# **Attachment A**

## **Building Envelope Modification Design Report**

Henning Larsen Architects have prepared a detailed building design for the Cockle Bay Park development as part of the application.

## Podium North

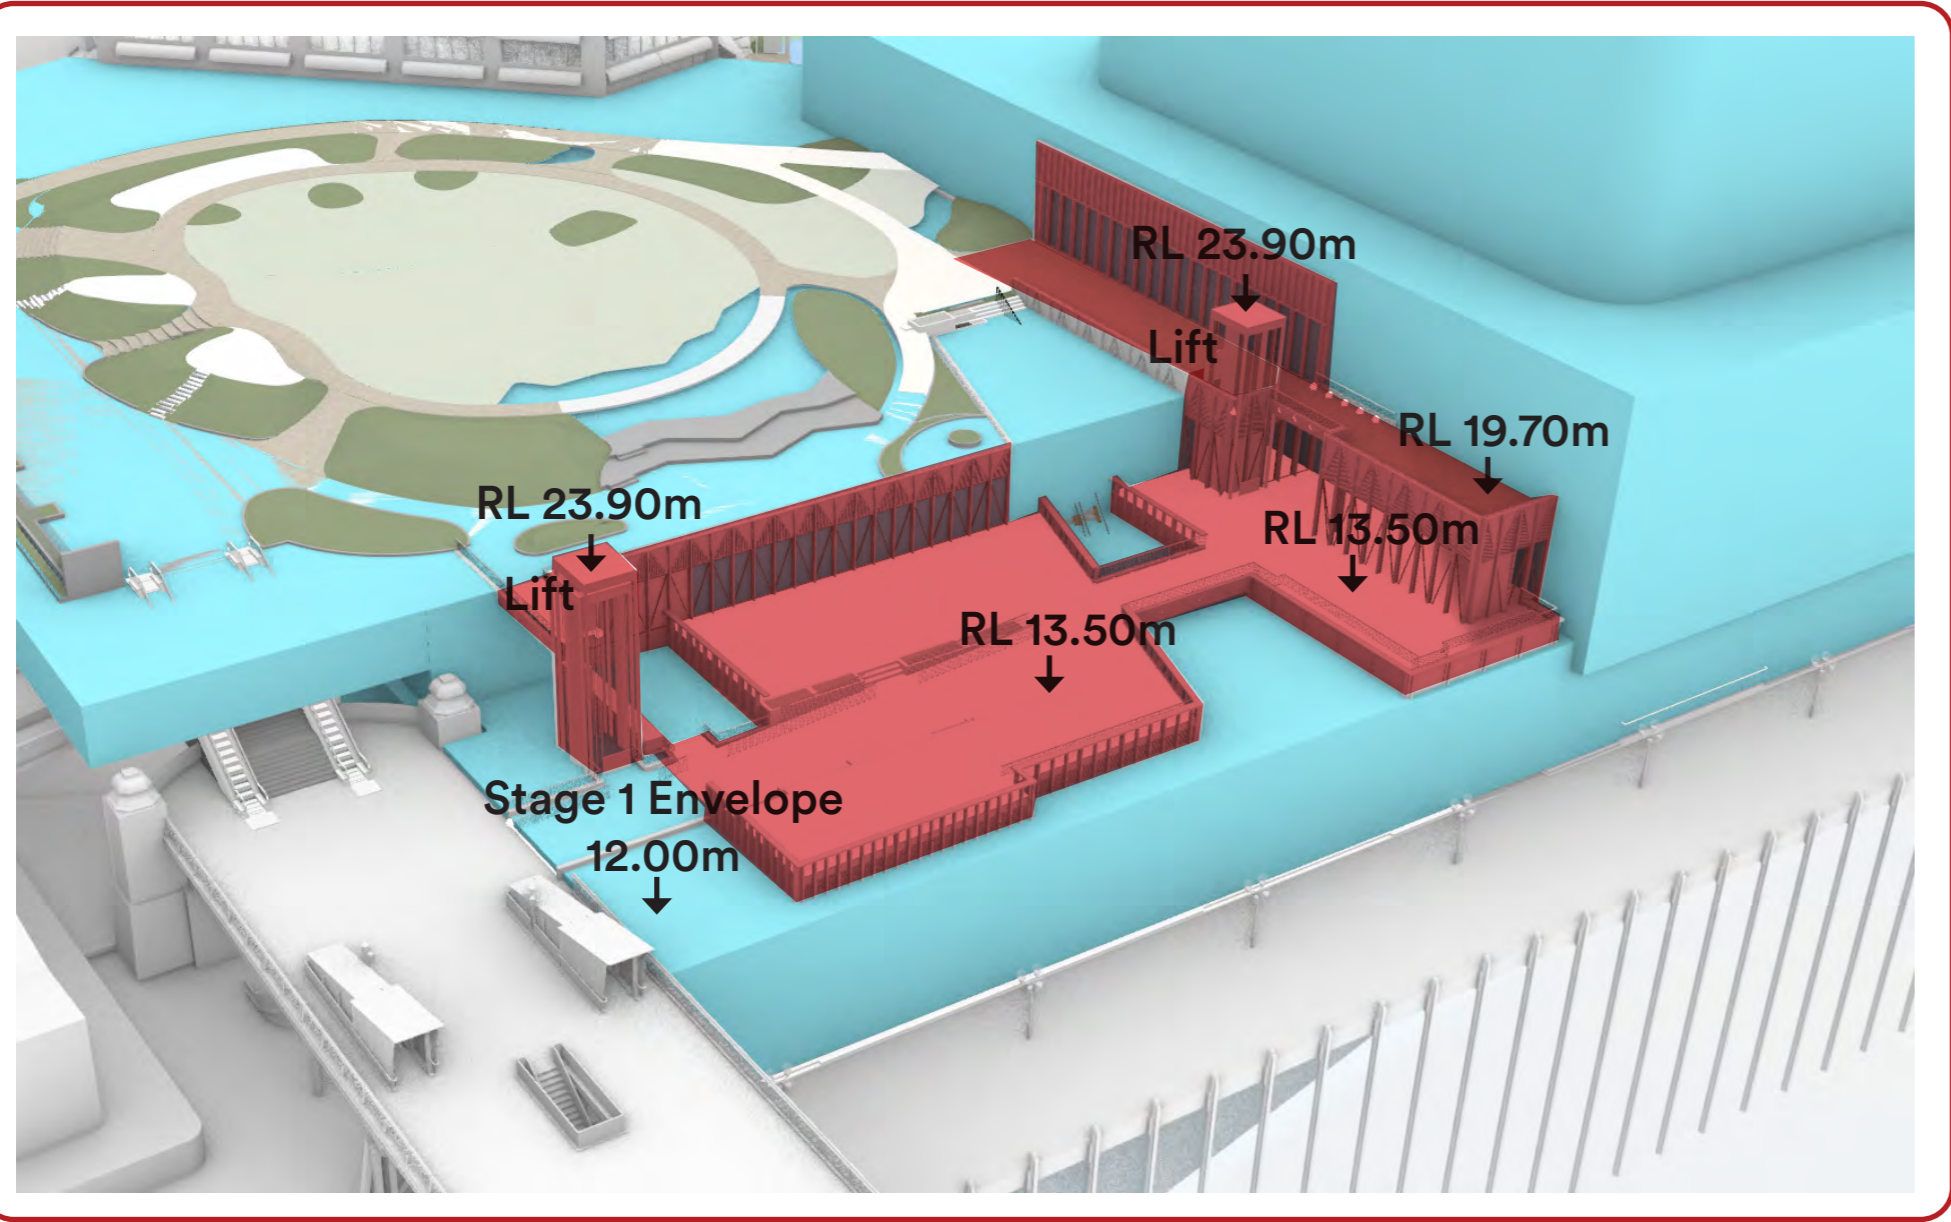
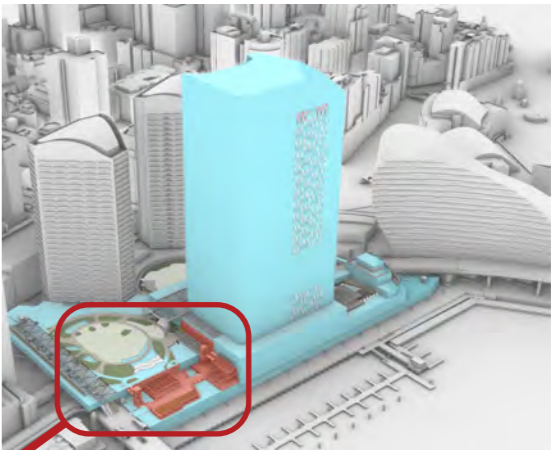
The updated scheme has pulled the built forms away from the Pyrmont Bridge heritage item as an improvement to the approved Concept Proposal and the competition scheme that had more built volume encroaching on this space.

This separation results in a more compact group of pavilions within the village forms of the podium, a new DDA compliant lift next to the Bridge and the northern circulation zone, and a generous ramp that connects Pyrmont bridge with Northern portion of the podium.

The proposed built form has been pulled back from the envelope in many areas, however the height of the building in this area has been adjusted to provide better amenity through functional floor to floor heights and enable greater flexibility in building usage in the future.

# Podium South

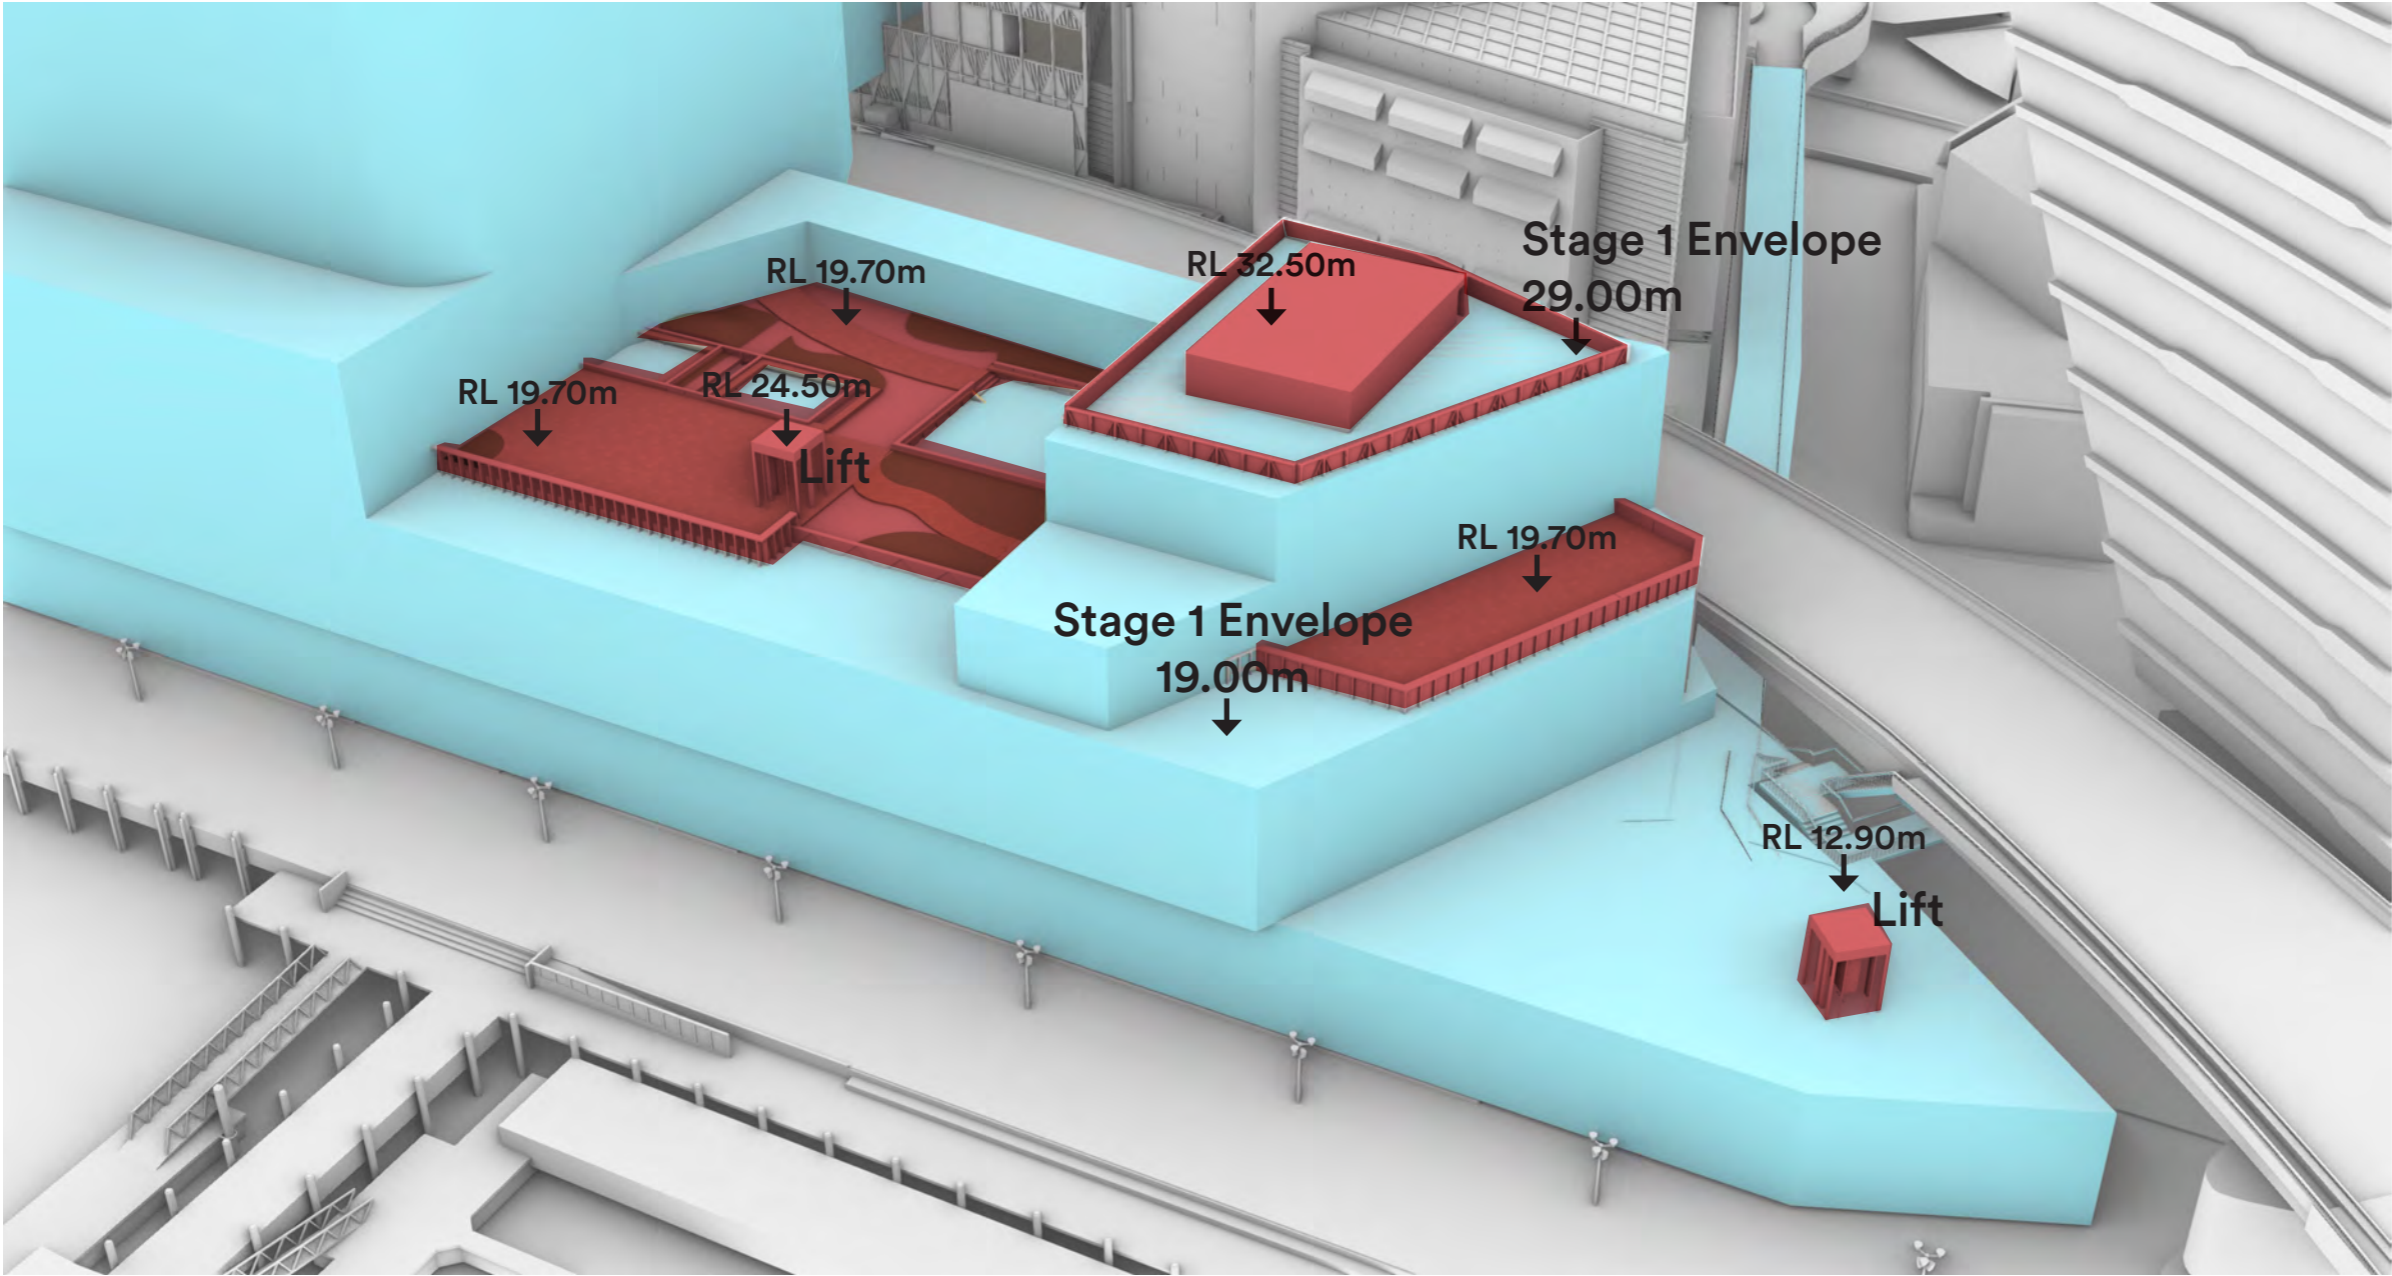
In order to facilitate equitable access to all public open spaces and retail tenancies, a number of lifts have been designed to support the circulation requirements of the Southern end of the podium. These elements will enhance the activation of the Southern park, improve the pedestrian movement along the Level 1 street and enable access to a special destination space above the park in the southern anchor tenancy.

The scheme now also includes the provision of stair access and kitchen exhaust plant spaces on the rooftop of the Southern podium volume. Stair access will allow the rooftop photovoltaic panels to be maintained. The height of these volumes has been minimised and are not deemed to adversely affect sightlines across the development or cause impact on the surrounding amenity.

# Northern Park

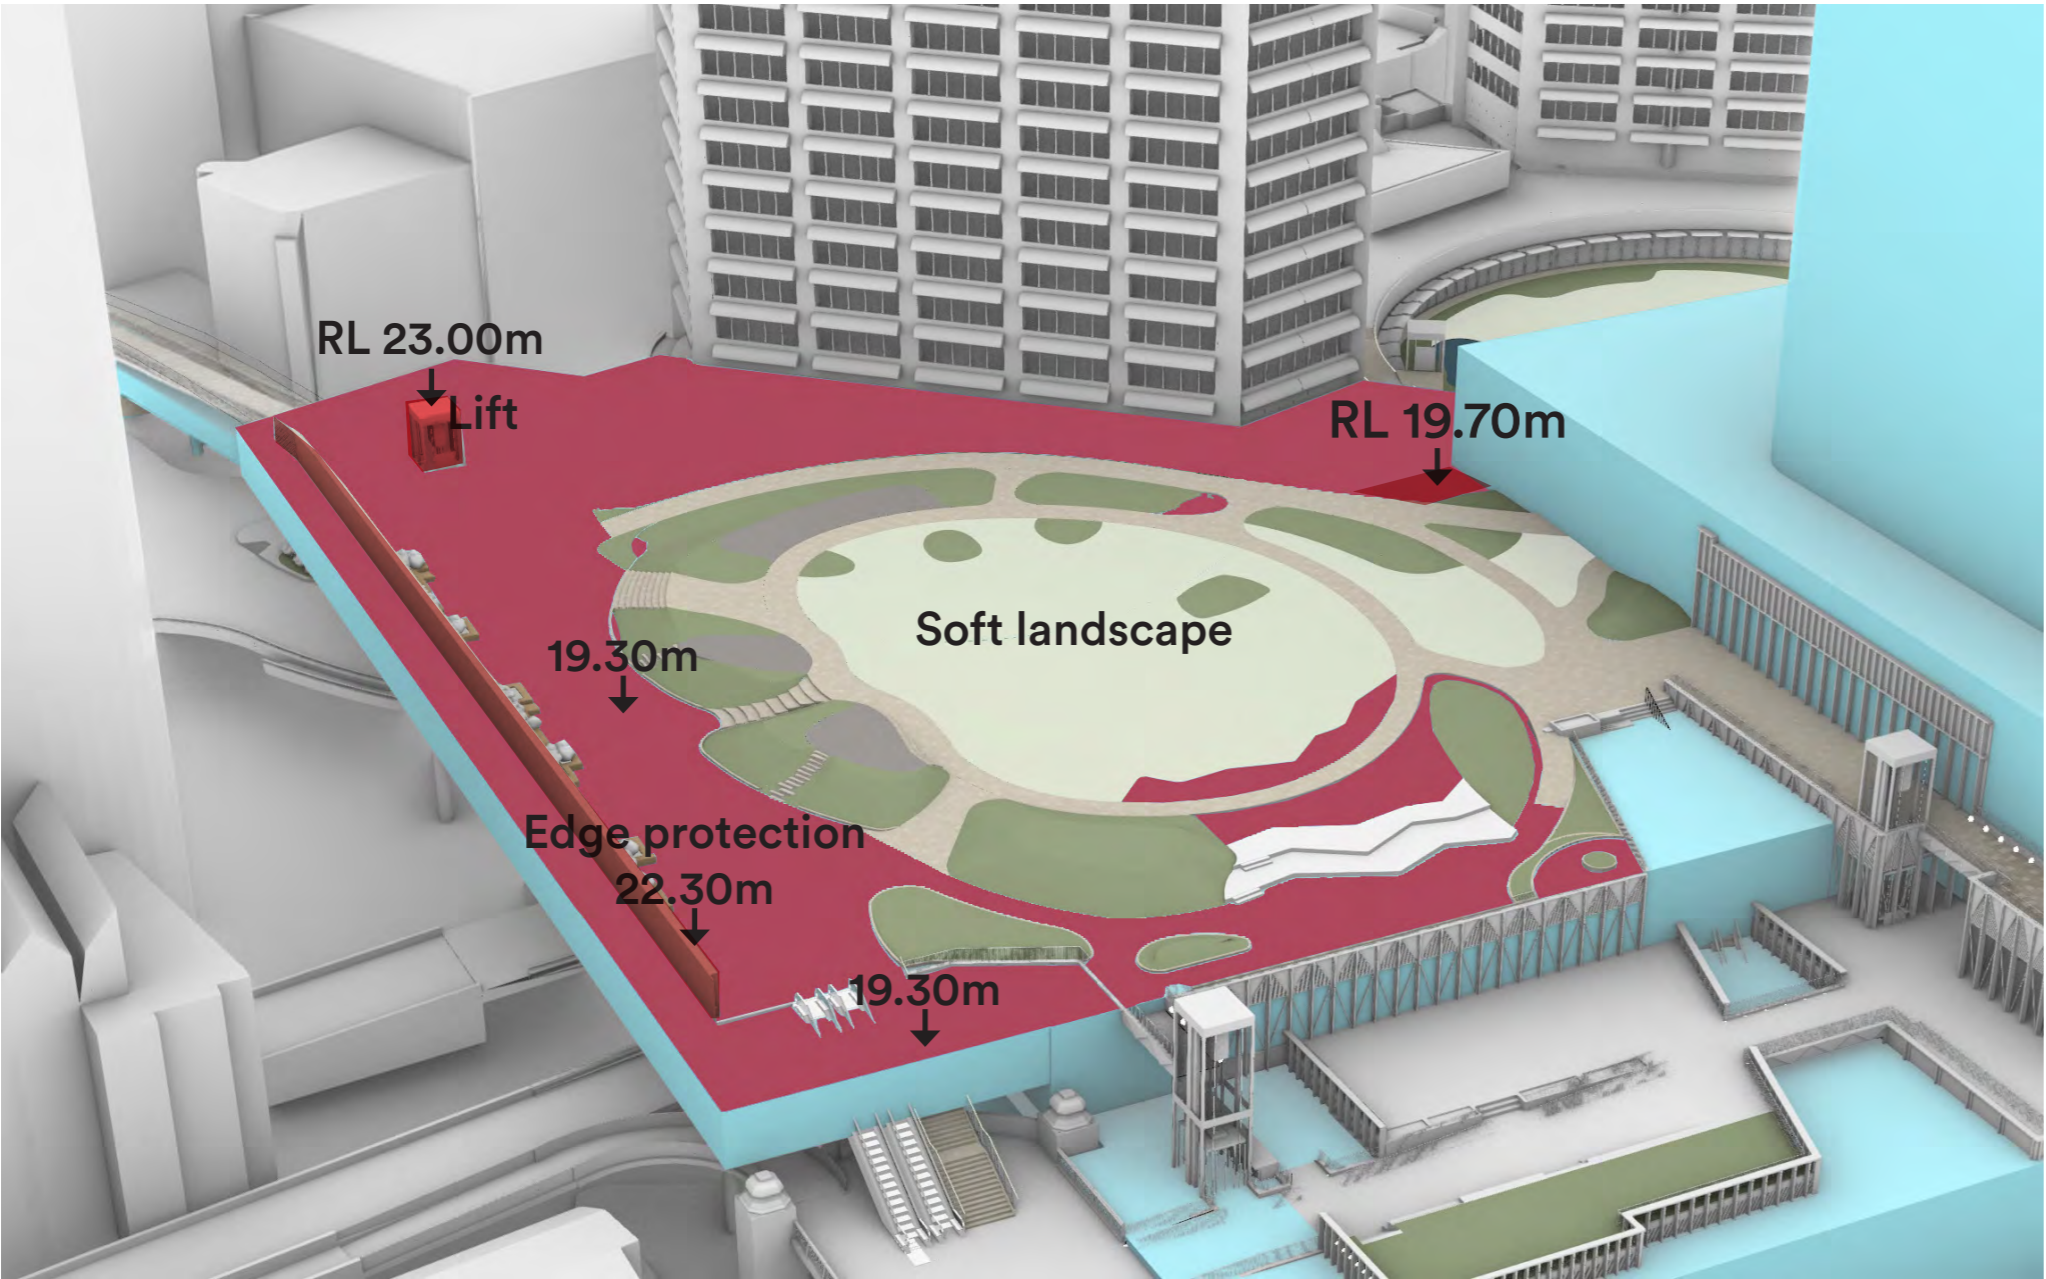
Refinement of the landbridge structure over the Western Distributor at the Southern end of the site has resulted in the finished floor levels of the Tower Lobby and surrounding external spaces being at a higher RL than originally envisaged. The landbridge, rises to 19.3m to allow clearance to Western Distributor roadway below.

Further, in order to provide sufficient soil depth for the desired planting, the landbridge deck's park landscape is increased at various amounts., This is detailed further in the clarifications section of this report.

A wall has been erected on the Northern edge of the park to provide protection to the Western Distributor below and is a requirement resulting from consultation with Transport for NSW (RMS) during the preparation of the Stage 2 SSD DA.
